CMD: 22-M37

Technical briefing

CNSC staff update on elevated hydrogen equivalent concentration discovery events in the pressure tubes of reactors in extended operation

**All nuclear power plant licensees**

Figure 2: Test specimen showing Vee-notch flaw (Source: Bruce Power)

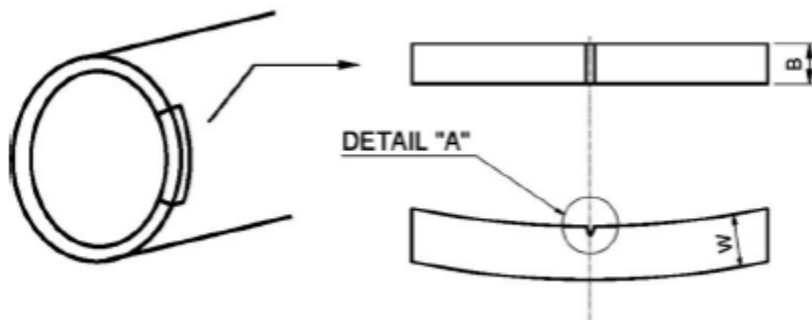
Early test results showed no changes between  $K_{IH}$  and  $p_c$  for material with Heq of 60 ppm or 240 ppm. These results suggest that the current model could demonstrate that there is no reduction in crack initiation behaviour for pressure tubes with elevated Heq. Additional tests have been completed for a specimen with a specific flaw geometry (See **Figure 2**).

The results from these tests generated about a 19% reduction in the crack initiation threshold for the 240 ppm tests compared to the 60 ppm tests. The current industry theory is that the finding is the result of an interaction between hydrides forming at the flaw tip and larger bulk hydrides present in the 240 ppm material that are not present in

the 60 ppm material. Therefore, it may be necessary to modify the DHC model to account for this finding, specifically for material with elevated Heq.

CNSC staff concluded that these results do not indicate an immediate concern for the Heq scrape measurement flaws that have been introduced to the ORJ-BM ROI in Bruce Unit 3 pressure tubes. Bruce Power provided a detailed stress analysis for the scrape flaws and demonstrated that the stresses arising from scrape flaw geometry are well below the stresses that would be required to initiate cracking. The flaw geometry used in the testing generates more significant stresses when compared to scrape mark geometries and even if the 19% reduction in the crack initiation threshold observed in those was applied to the scrape flaws, the stresses would not be high enough to initiate cracking.
